GLOBAL TECHNOLOGY CENTER RENOVATION & EXPANSION

SHEET NAME
SITEPLAN

SHEET NUMBER
CS102

1 SITE PLAN
SCALE: 1" = 30'

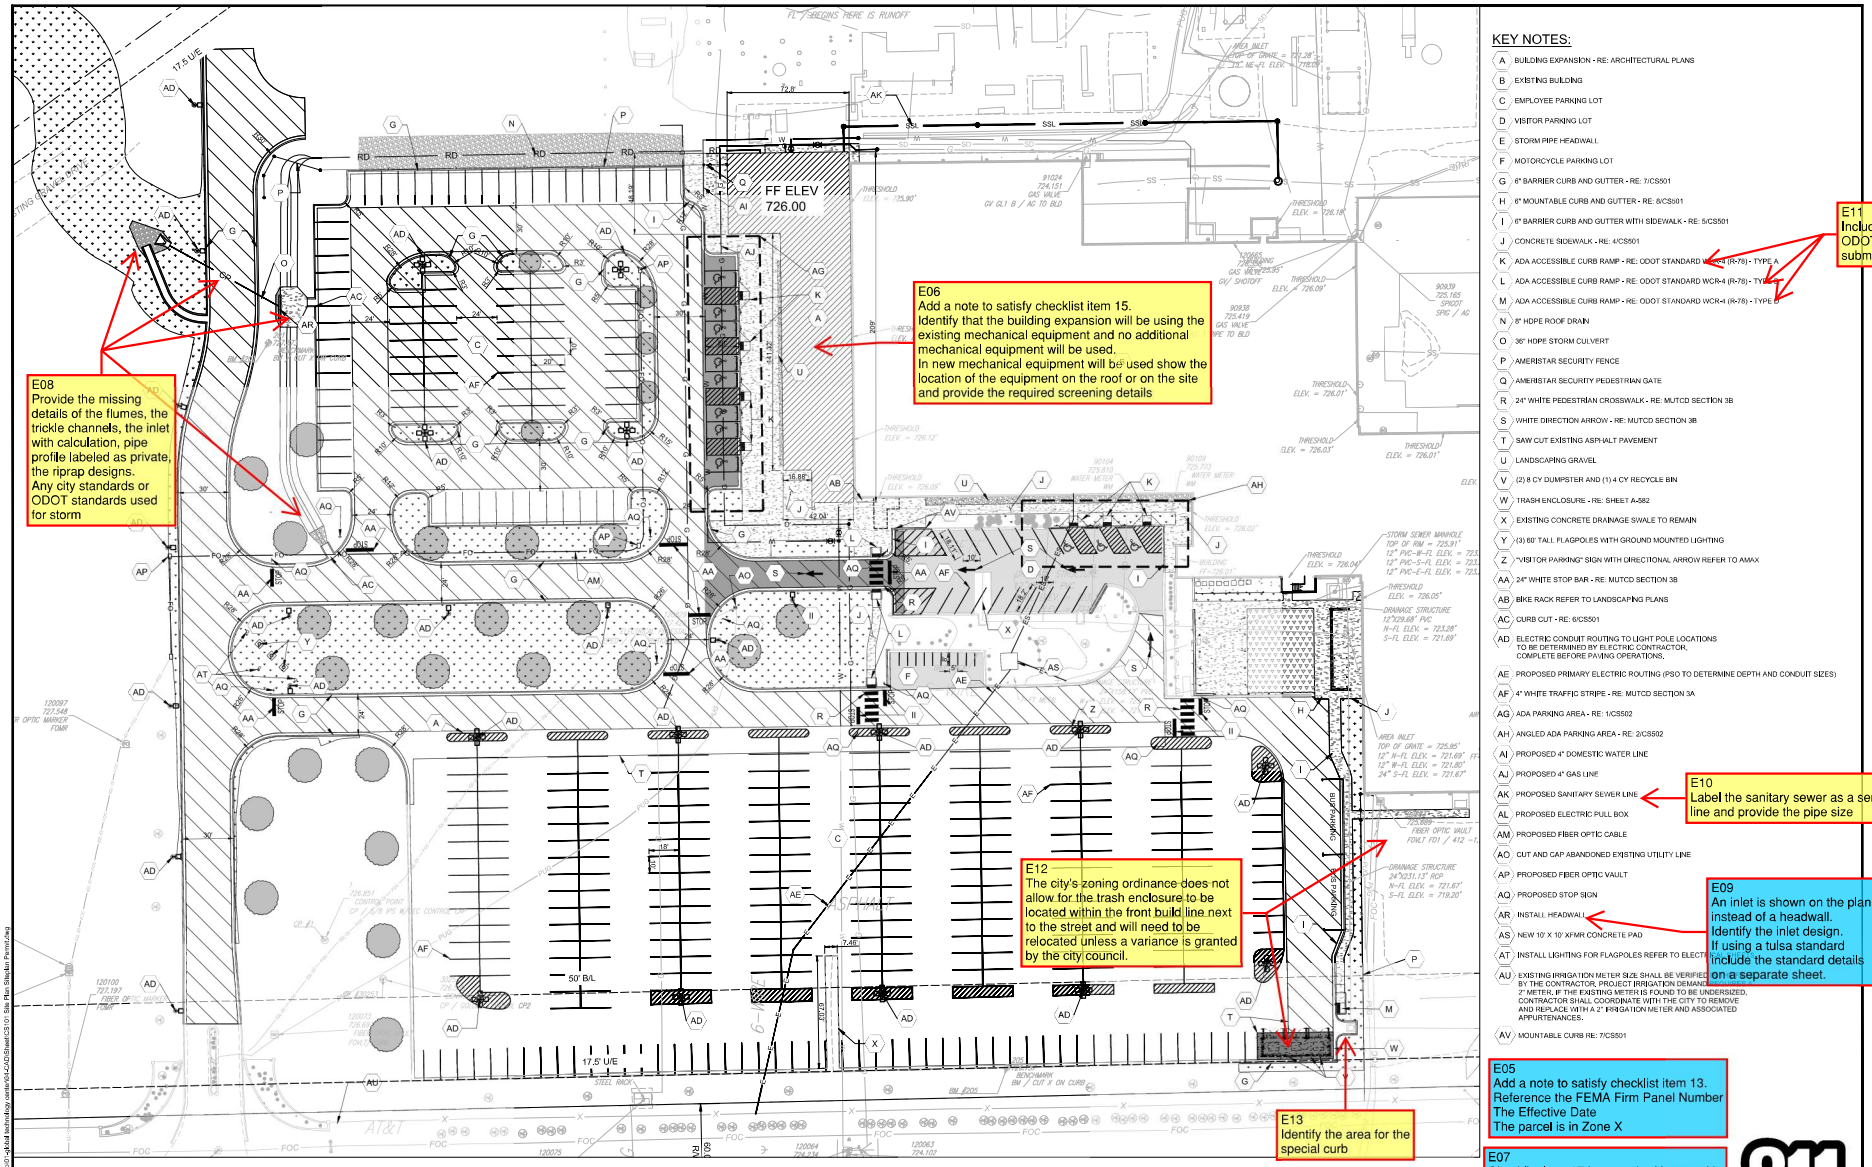
P01: Please include a landscape plan meeting the requirements of Sec. 4-3-6.

P02: Main requirements are 1 tree per 15 parking spaces on new lot. Must be within 15 ft of lot or within landscape islands.

P03: Landspace islands must be 10ft by 18 ft and must be protected by a vertical curb.

P04: No parking spot more than 75 ft from landscape area.
